Access Compliance Report

Public Rights-of-Way

(Curb Ramps)

Intersection ID: 9278	Main Street: OAKLAWN_AV	Cross Street: BOOKER_AV	Location:	E
ADA ID: E0A884CE0CD8	Ramp Type: Perp	Initial Pass/Fail: Fail	Overall Compliance: No	Severity Score: 10
Codes/Mitigation Info/Possible Solution		Field Measurements/Component Compliance

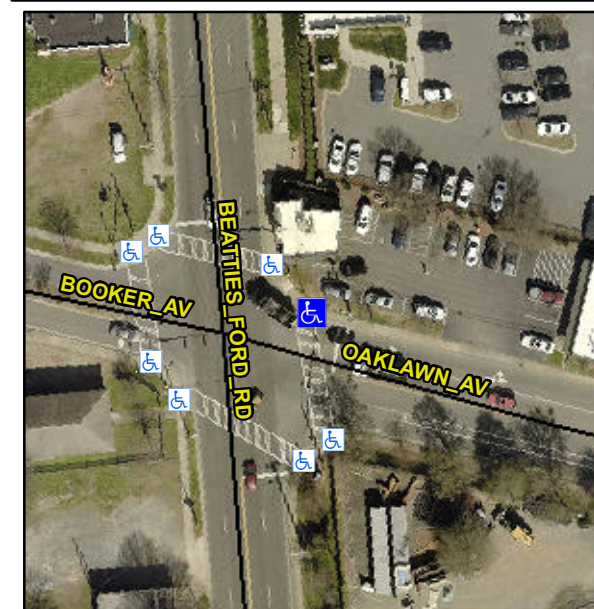
Not Found, R304.5.1, R304.5.3

Compliance	Description	Data	Compliance	Description	Data
N/A	Ramp Length (in)	59.5	Yes	Ramp Slope (%)	5.6
No	Ramp Width (in)	43.0	No	Ramp XSlope (%)	2.8
N/A	Flare Type LT	N/A	N/A	Flare Type RT	N/A
N/A	Flare Slope LT (%)	N/A	N/A	Flare Slope RT (%)	N/A
N/A	Flare Traversable LT?	N/A	N/A	Flare Traversable RT?	N/A
N/A	Landing Length (in)	N/A	N/A	DWS Provided?	N/A
N/A	Landing Width (in)	N/A	N/A	DWS Contrast?	N/A
N/A	Landing Slope (%)	N/A	N/A	DWS Length (in)	N/A
N/A	Landing X Slope (%)	N/A	N/A	DWS Full Width?	N/A
N/A	Landing Curb? (Y/N)	N/A	N/A	DWS Offset (in)	N/A
N/A	Shared Landing?	N/A			
N/A	Gutter Ponding?	N/A	N/A	Gutter Slope (%)	N/A
N/A	Gutter Lip Ht (in)	N/A	N/A	Gutter X Slope (%)	N/A
N/A	Painted X Walk1?	Yes	N/A	Painted X Walk2?	N/A
	X Walk 1 Direction	To S		X Walk 2 Direction	N/A
N/A	X Walk 1 Width (in)	113.5	N/A	X Walk 2 Width (in)	N/A
	X Walk 1 Slope (%)	2.2		X Walk 2 Slope (%)	N/A
	X Walk 1 X Slope (%)	1.6		X Walk 2 X Slope (%)	N/A

Remove & Replace Entire Ramp.
